**New Exhaust Safety Directive  
Apollo Delta Jet AS-III 912S  
Apollo North America, Inc.  
Dec 1st, 2006  
Requirement: Mandatory**

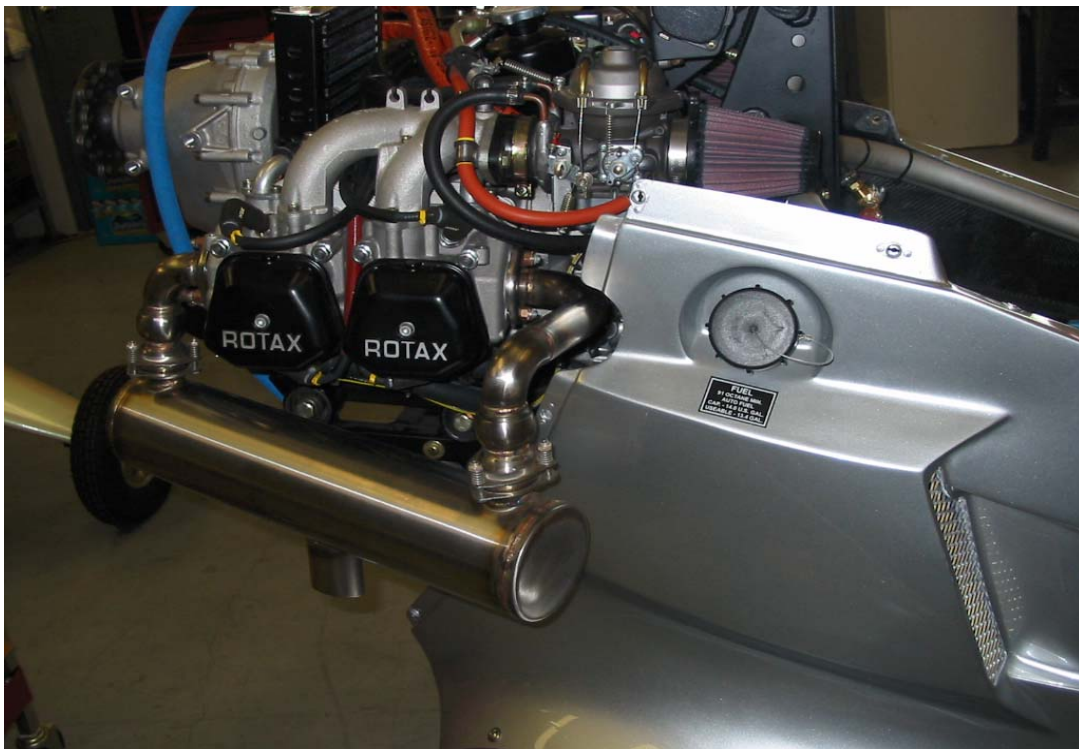
It will be necessary to trim the fiberglass on the Delta Jet body using a Dremel tool a bit by the mechanic as shown in the picture below
